**Ser.no. 10/660,708**  
**Amendment dated August 17, 2005**  
**In Reply to Office Action dated February 18, 2005**

**Amendments to the Drawings**

Annotated marked-up drawing - ser.no. 10/660,708

**Fig. 3**

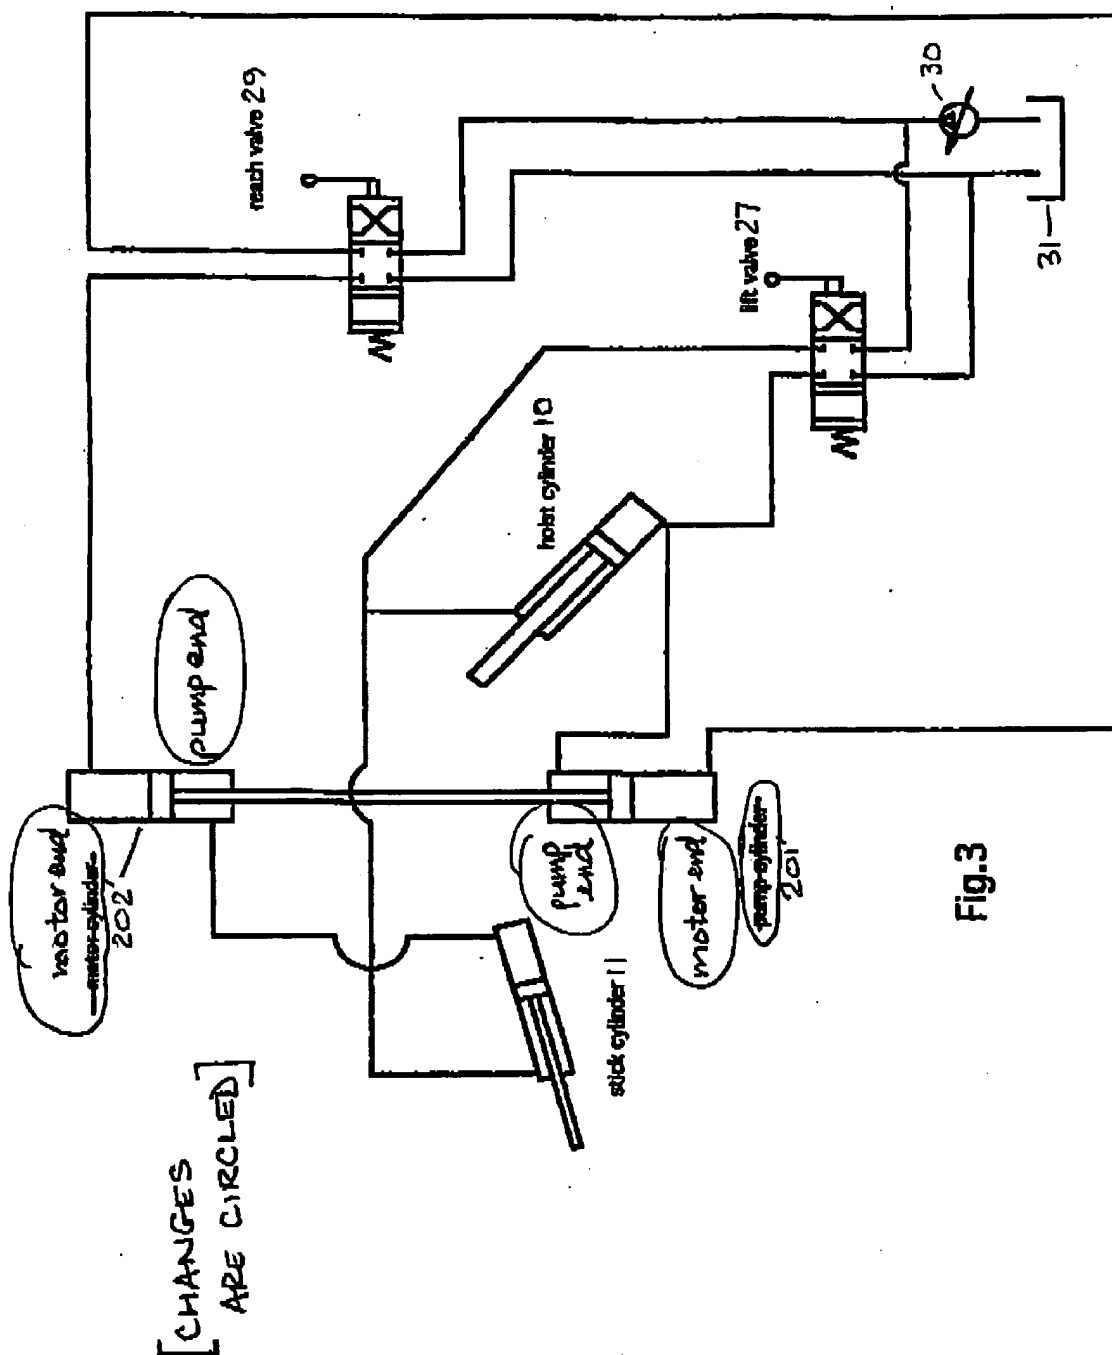
The attached sheet of drawings includes changes to Fig. 3. The sheet, which includes Fig. 3 only, replaces the original sheet including Fig. 3 only.

Fig. 3 has been replaced. The only differences are with respect to labeling, for greater clarity. Specifically, the motor end and pump ends of the motor cylinder 202' and pump cylinder 201' have been indicated in replacement Fig. 3.
